May 22, 2020

Project No. 16129

**Re: IDE-2020-17
Clair-Maltby Secondary Plan – Open Space System Strategy
2009, 2021 and 2093 Gordon Street, Guelph**

COMPONENTS OF RECOMMENDED OPEN SPACE SYSTEM

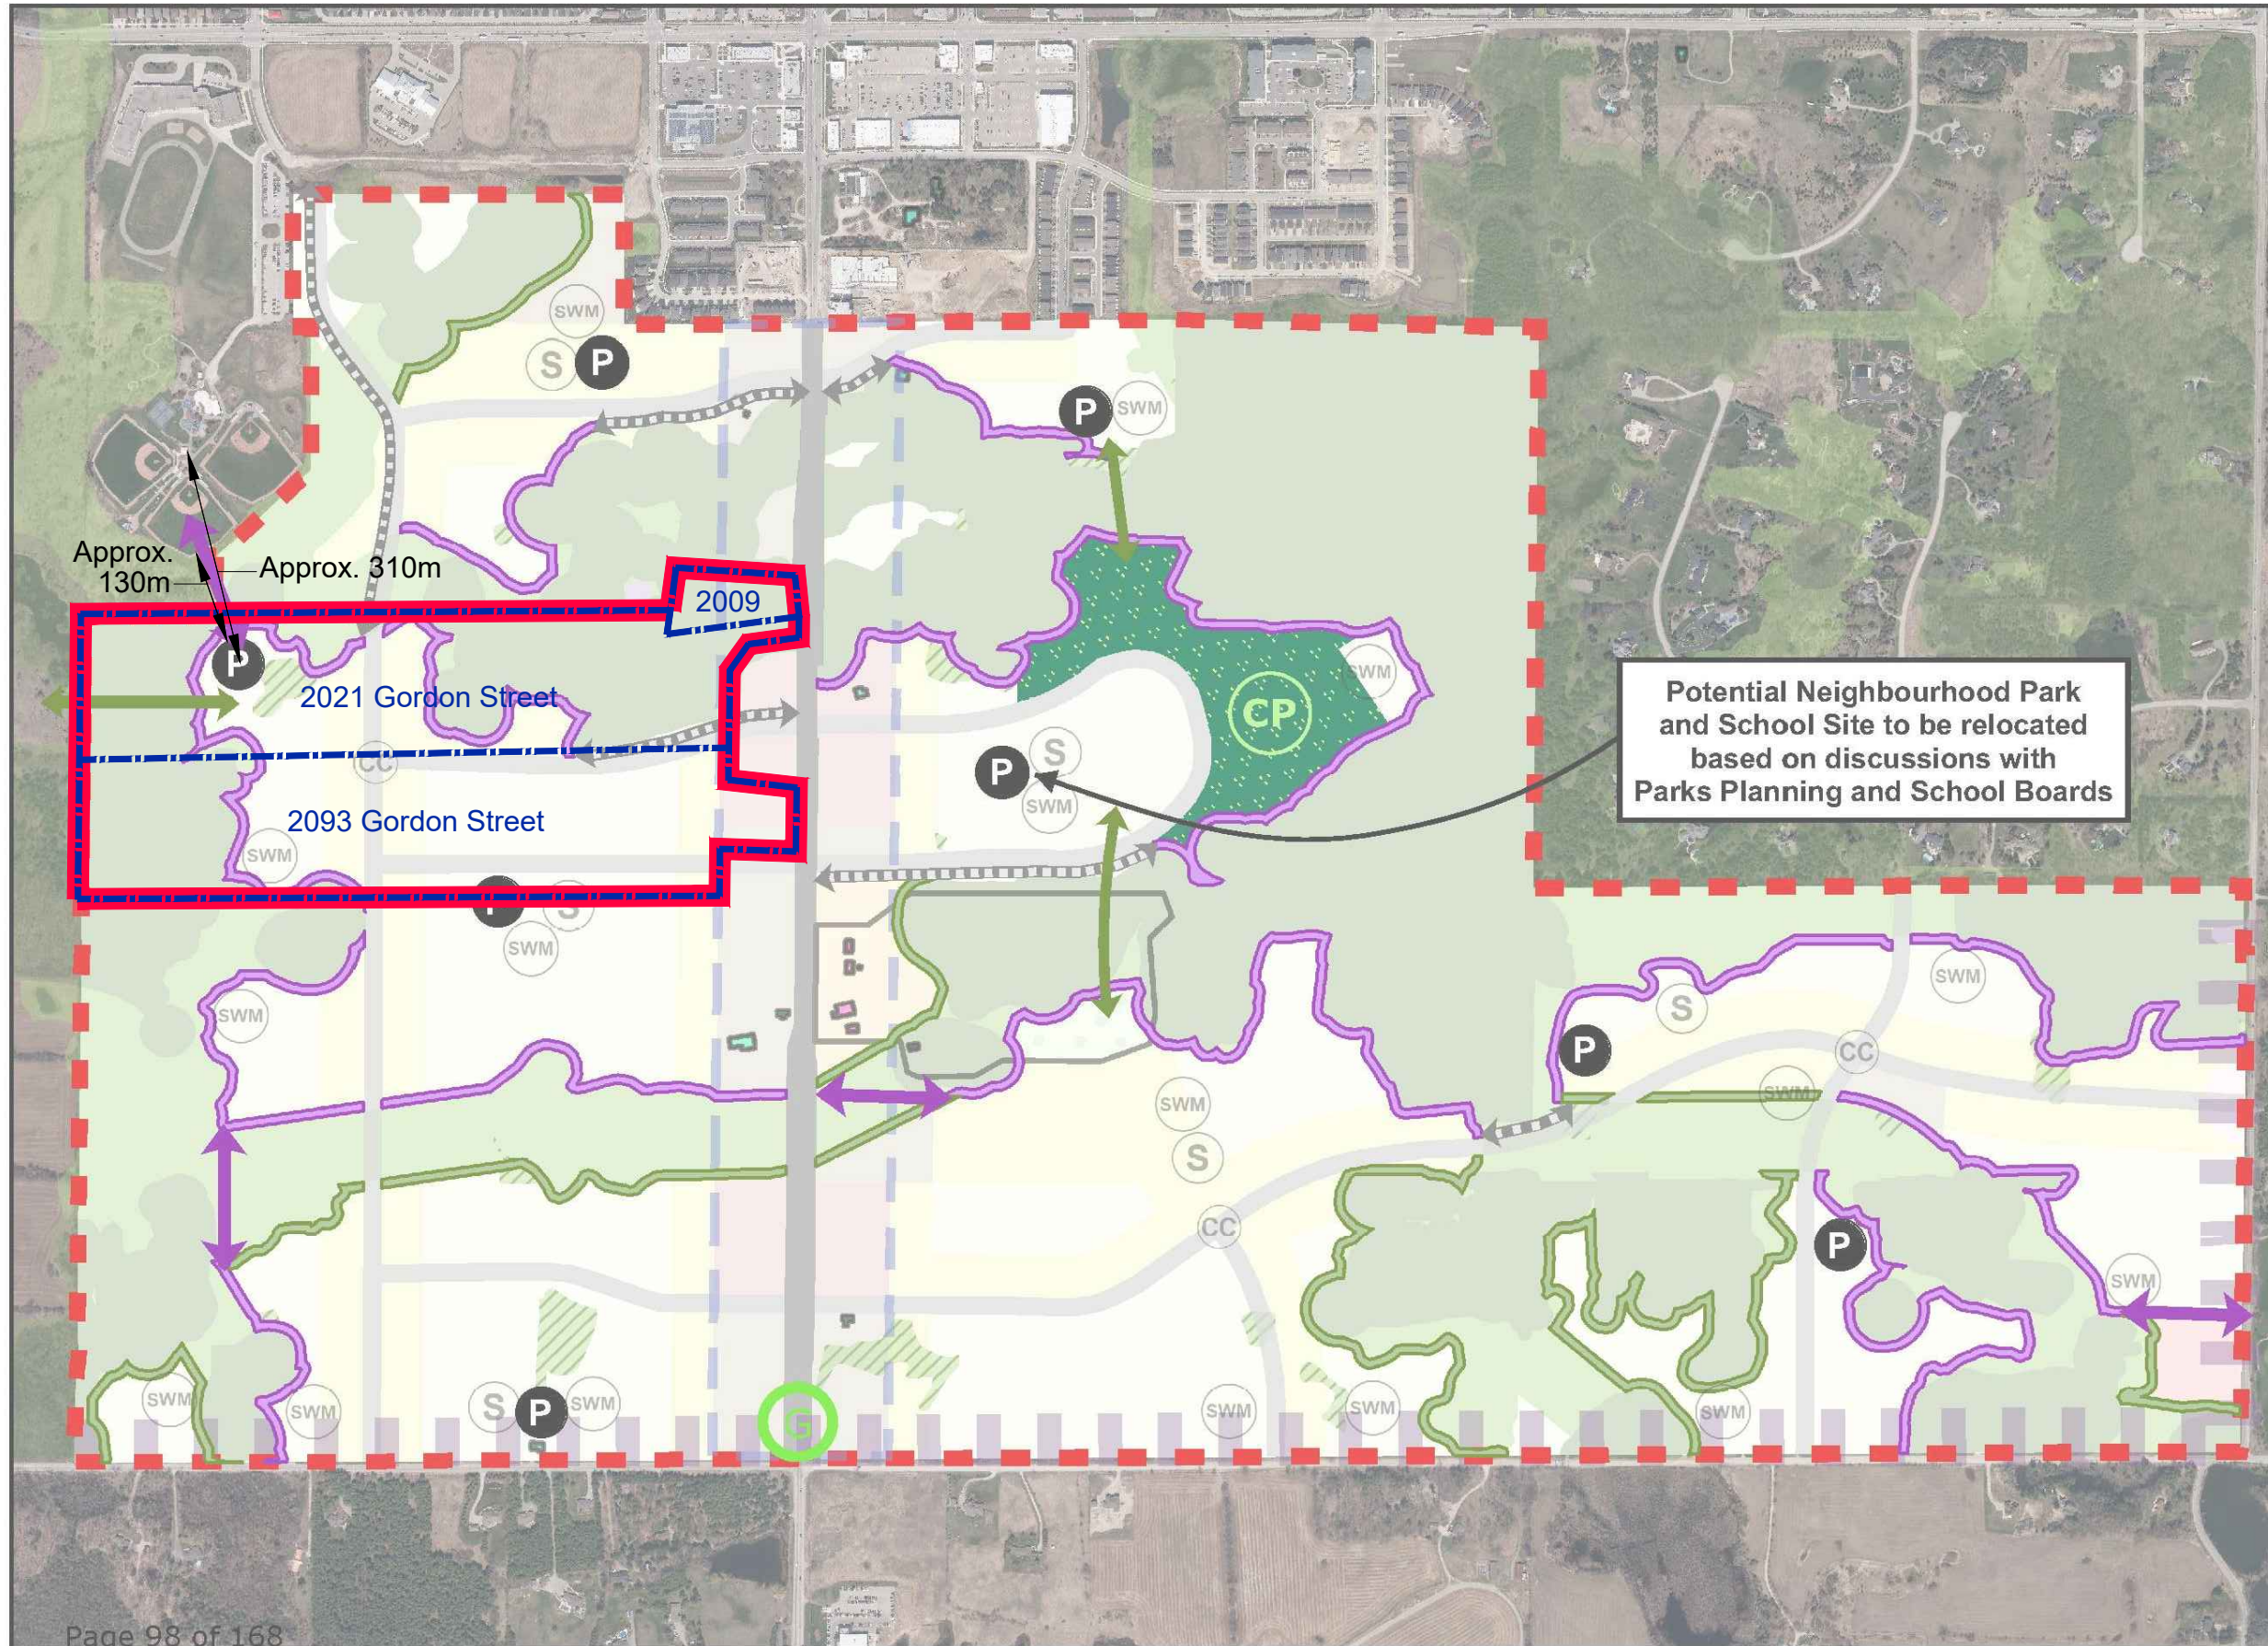
We note the location of the Neighbourhood Park in the northwest corner of the Site (2021 Gordon) in relation to the existing Community Park (South End Community Park). Based on our calculations, the two parks would be approximately 140 metres from each other (and a little over 300 metres from centre of park-to-park), with a proposed trail connection between them – see attached overlay map. Given the proximity of the parks, we believe there are better locations for this proposed Neighbourhood Park that are strategically located and further from the existing large Community Park. These alternate locations should be explored during the development of the Secondary Plan.

A Natural Heritage Overlay area is shown on the Site (2021 Gordon) next to the proposed Neighbourhood Park – see attached overlay map. It is our understanding that this Natural Heritage Overlay represents areas of potential natural heritage interest. We would like to note that this Natural Heritage Overlay shows features that do not actually exist and is currently being farmed. On-site confirmation of these features has not occurred to date. It is our understanding that such areas will require further study/analysis at the time of future planning applications (i.e. draft plan of subdivision,

zoning, etc.) and therefore could be amended. We would ask for confirmation from City staff.

We note that the proposed Neighbourhood Park on 2021 Gordon is shown next to the proposed moraine ribbon feature. There are other examples of this within the Clair-Maltby area (i.e. park adjacent to the moraine ribbon). We have concerns that the proposed moraine ribbon feature area will be added onto land area of the park when this could be part of the overall park size. In such cases, we recommend that moraine ribbons not be shown where they abut parks, because the intent of the moraine ribbon is captured by the park. We would appreciate further consideration of this through the development of the Secondary Plan.

It is our understanding that the latest limits of the proposed refined Natural Heritage System area are shown on the Open Space System Strategy mapping. The Natural Heritage System area has increased in size on the Site through the Secondary Plan process to date, despite the lack of on-site field surveys or verifications. It is our understanding that such areas will require further study/analysis at the time of future planning applications (i.e. draft plan of subdivision, zoning, etc.) and therefore could be amended accordingly. We would ask for confirmation from City staff.
